**Pacific Gas and  
Electric Company®**

PG&E Letter DCL-14-076

Diablo Canyon Units 1 and 2

Pacific Gas and Electric Company's Third Six-Month Status Report in Response to  
March 12, 2012, Commission Order Modifying Licenses with Regard to  
Requirements for Mitigation Strategies for Beyond-Design-Basis External Events  
(Order Number EA-12-049)

Figure 8A  
 All Strategies - Alternate  
 Units 1 and 2  
 Elevation 115'

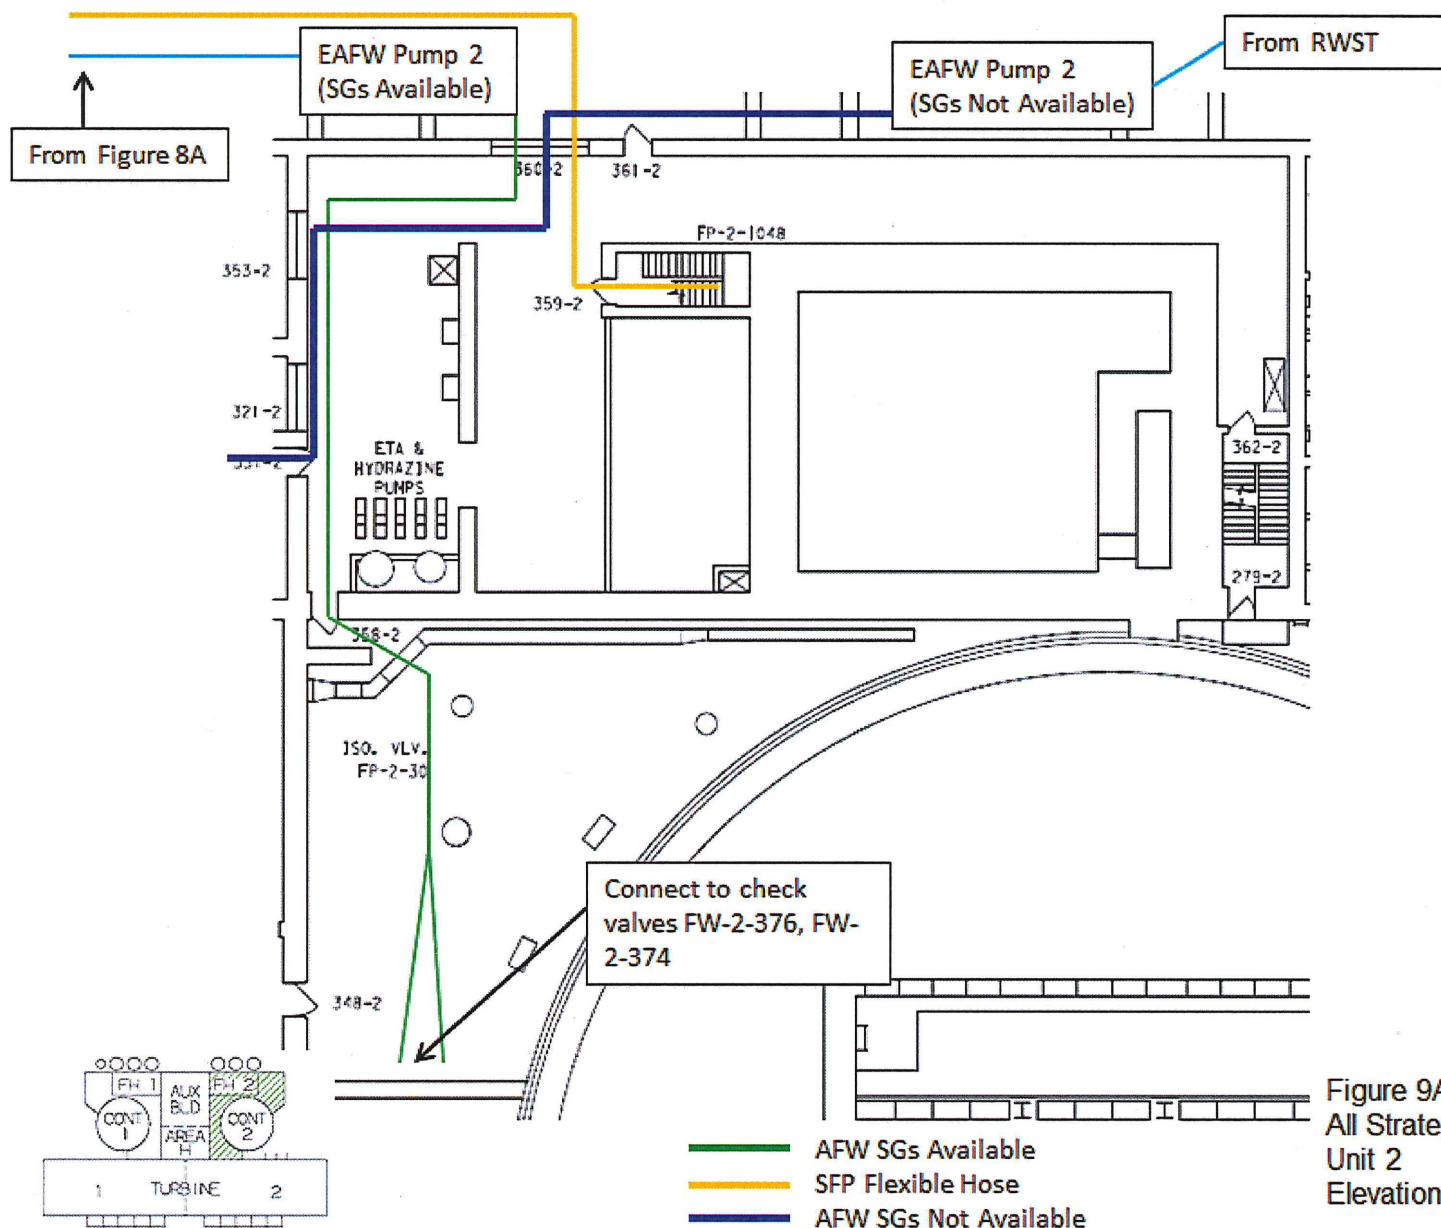
- (e) Added note "To Figure 6B" for lines that connect from the Unit 2 ERCS make-up pump.
- (5) Figure 8A Revisions:
- (a) Removed the ESFP pump from the SFP hose line.

- (d) Removed the staging location for the ERCS make-up pumps from the 115-foot elevation (now on the 100-foot elevation).
  - (e) Modified route for 480-V generator cables to be routed down the stairwell for the ERCS make-up pumps.

- (f) Updated the legend to include route for 480-V generator cables for powering the ERCS make-up pumps.
  - (g) Updated the legend to remove reference to "RCS SGs Available."

- (h) Clarified "To Unit 2" to "To Figure 9A."
- (6) Figure 8B Revisions:
- (a) Added staging location for the Unit 1 ERCS make-up pump.
  - (b) Added route for 480-V generator cables to the ERCS make-up pumps.

Figure 9A  
All Strategies – Alternate  
Unit 2  
Elevation 115'

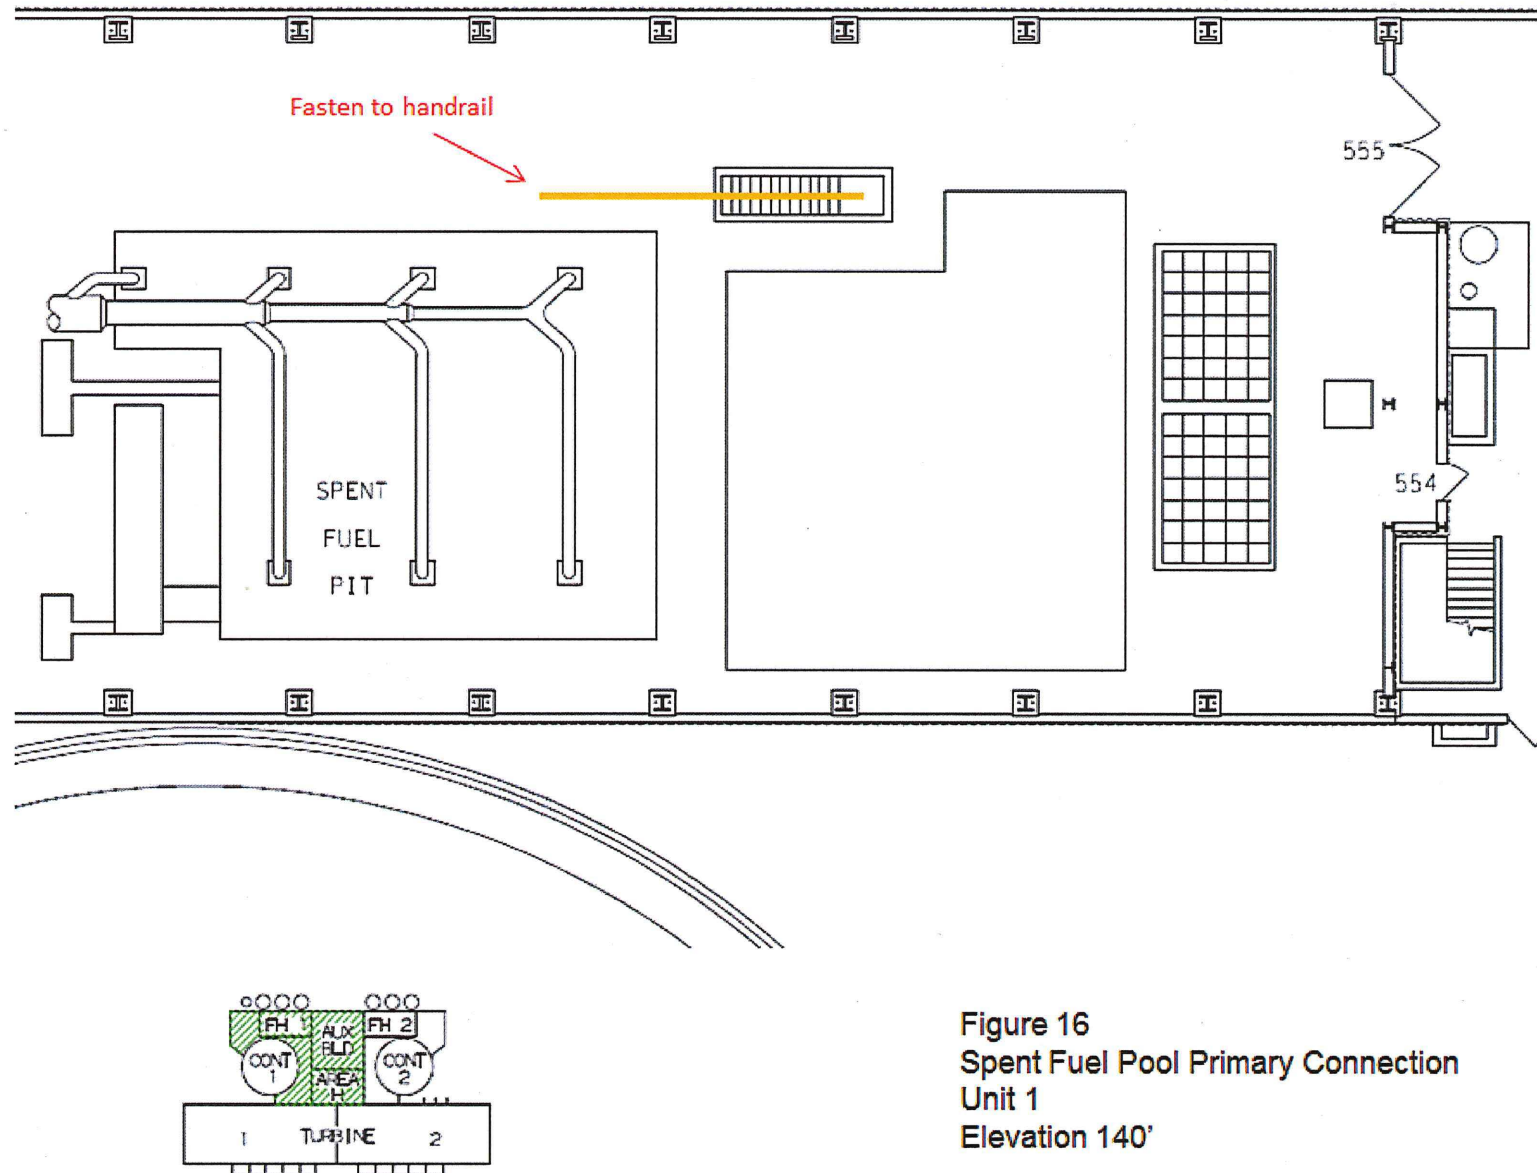
- (e) Clarified the legend to state "SFP Flexible Hose."
  - (f) Added note "To Figure 9B" for lines that connect to the Unit 2 ERCS make-up pump.
- (7) Figure 9A Revisions:

- (a) Removed the ESFP pump from the SFP hose line.
  - (b) Clarified the legend to state "SFP Flexible Hose."
  - (c) Clarified "From Unit 1" to "From Figure 8A."
